LIGO Laboratory

Date:	31 March 2009	Refer to:	L0900059-v1
Subject:	Notes on the optomechanical layout meeting, 31-Mar-2009		
To:	Ed Chavez, Mike Smith, Calum Torrie, Luke Williams		
From:	Dennis Coyne

Figure 1: PDMWorks Vault directory & file structure for integrated optomechanical layouts

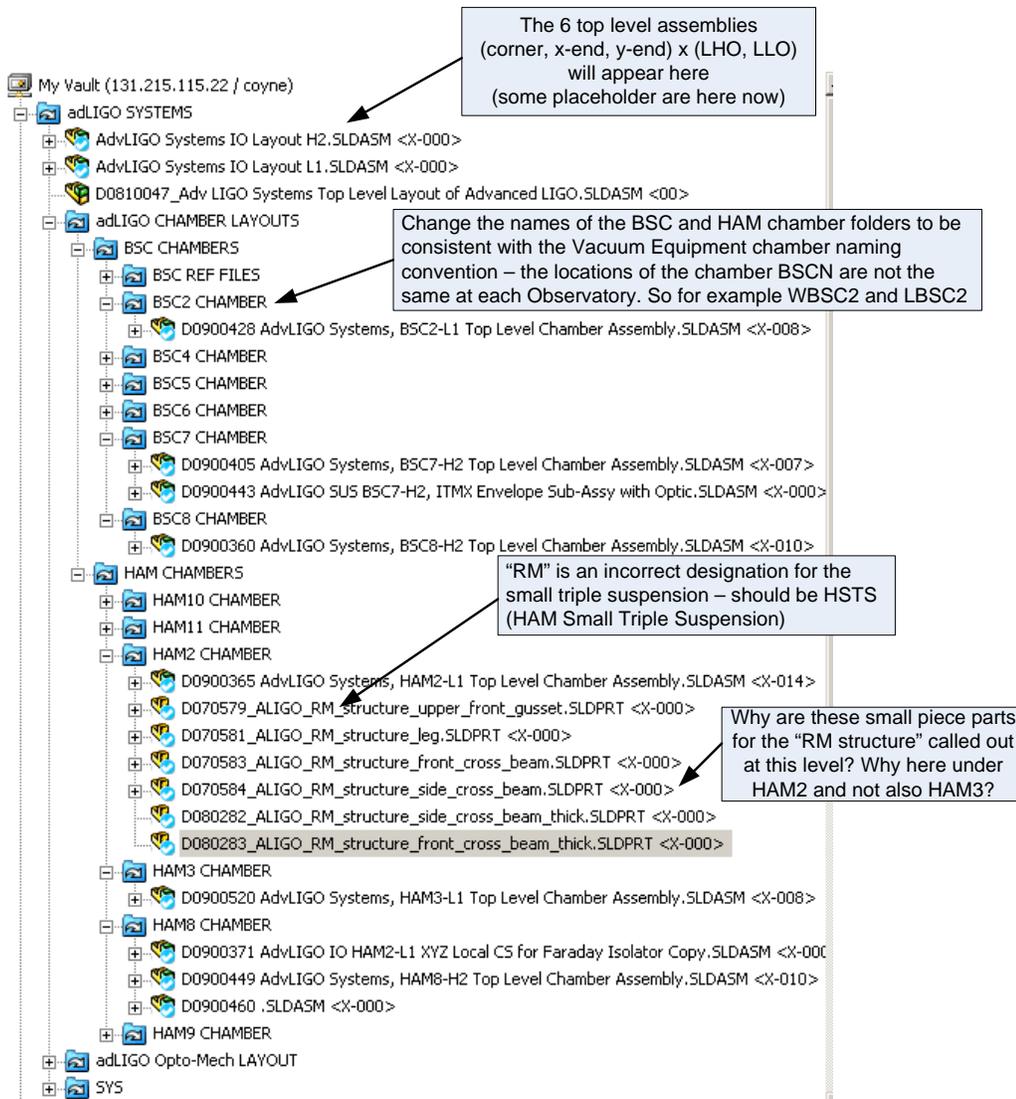
- 2) The chamber folder names must change to be consistent with the Vacuum Equipment chamber designations. For example, BSC2 should be either WBSC2 or LBSC2 (meaning either Washington, LHO BSC2 or Louisiana, LLO BSC2). Note that not all BSCN chambers are in the same location at the two observatories – see Figure 2, Figure 3, and Figure 4
- 3) Note that “RM_structure” is no longer the proper name. It should be “HSTS_structure”. A minor point to be eventually corrected. See Figure 1

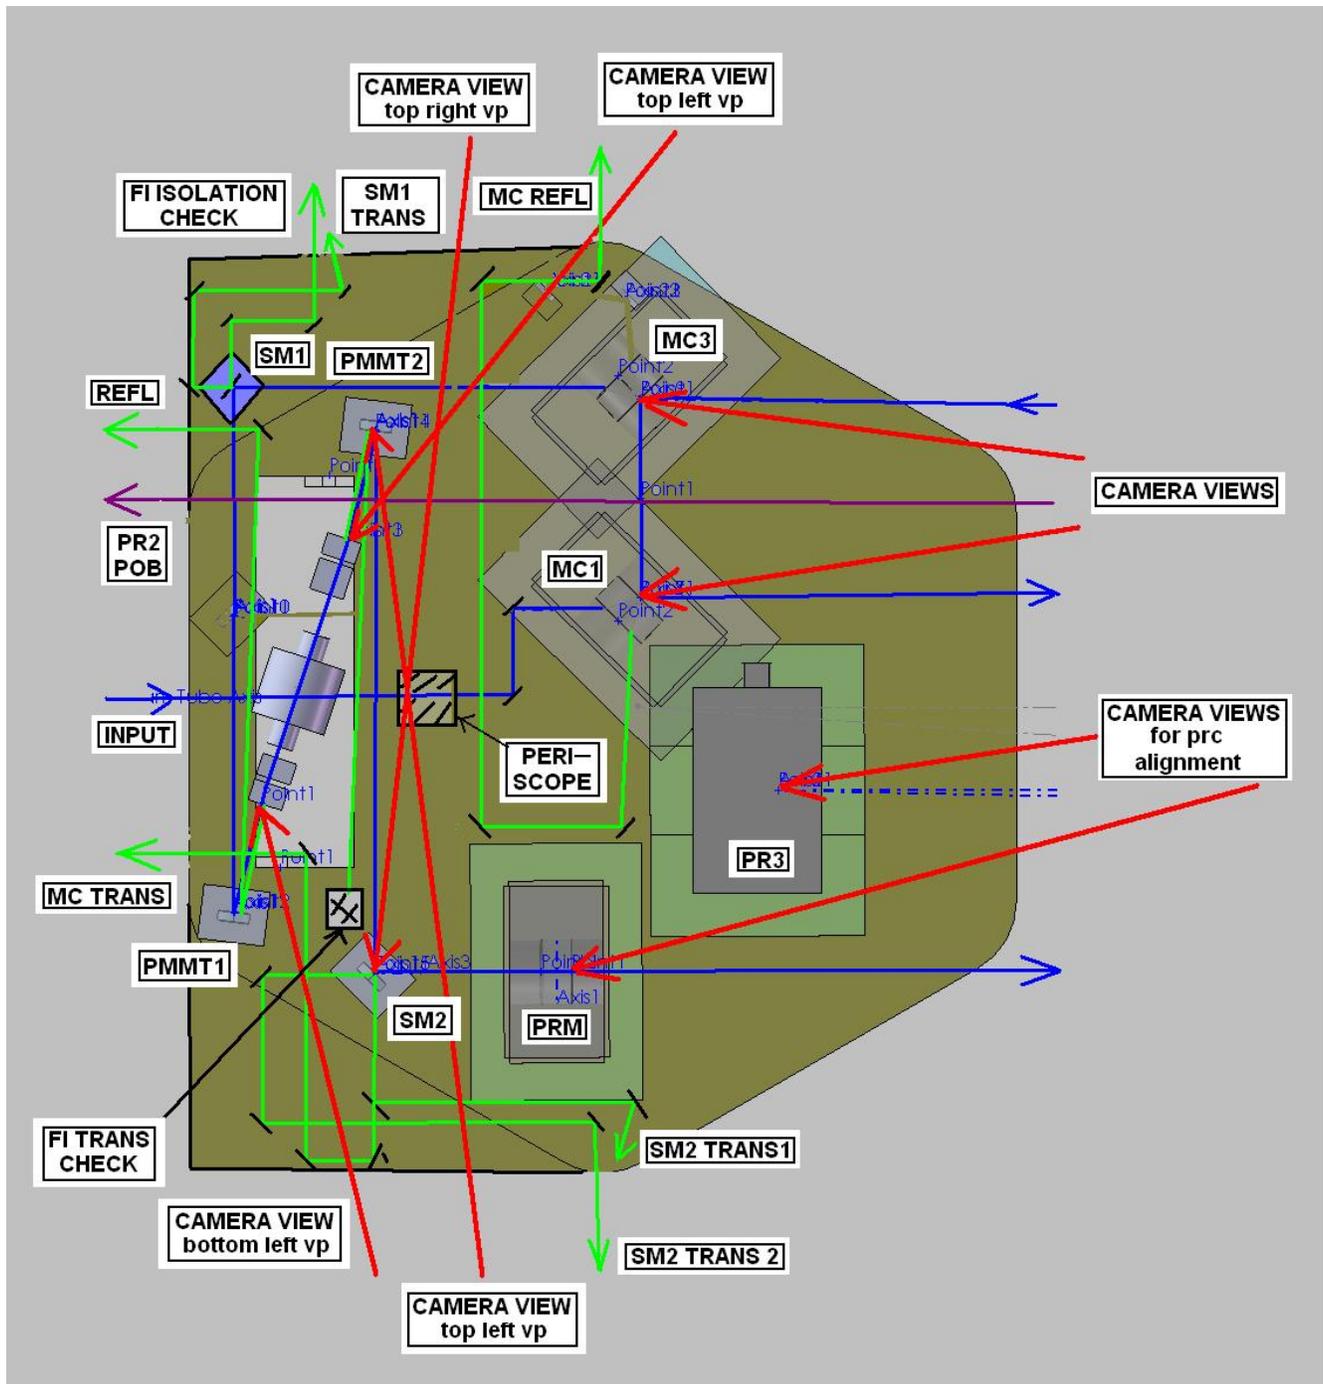
- 10) The HAM2 layout in the PDMWorks vault is not the latest layout as discussed at the layout & interface meeting held recently at UFL ([L0900030](#)). Luke subsequently created a very rough, notional layout more consistent with the layout discussed at the UFL meeting (see Figure 5). This layout extends too far beyond the table. It is not advisable to have large table extensions and we may not have the mass available to make even small, stiff table extensions. IO (Luke) was encouraged to work on layout alternatives to either eliminate the need for table extensions or minimize their extent. We discussed a couple of possibilities to make a more workable layout, e.g. rotate the {SM1, PMMT1, FI, PMMT2, SM2} ensemble clockwise about PMMT1 until SM1 is on the optics table & shift the PSL injection periscope to the right, use periscopes to point beams off to viewports, consider adding viewports, consider sending beams to HAM1 instead of IOT1, etc.

Figure 5: VERY ROUGH, NOTIONAL Layout for HAM2 shown with Optics Table Extensions which are far too large – working to eliminate need for optics table extensions or minimize extensions. Note that the PRM HSTS must be able to move +/- ~25 mm (not sure of this value) in order to accommodate uncertainty in the ROC. Consequently SM2 cannot move closer to PRM. Not shown in this image is the magnetic field keep-out zone for suspensions (ellipsoidal volume surrounding the Faraday Isolator). This keep-out zone might be minimized with the addition of a magnetic field containment shield of iron around the FI magnets.

Action: Luke to try different layout scenarios in attempt to move all SOSs onto the table and minimize or eliminate the need for fixed mirror mounts beyond the current extent of the optics table.
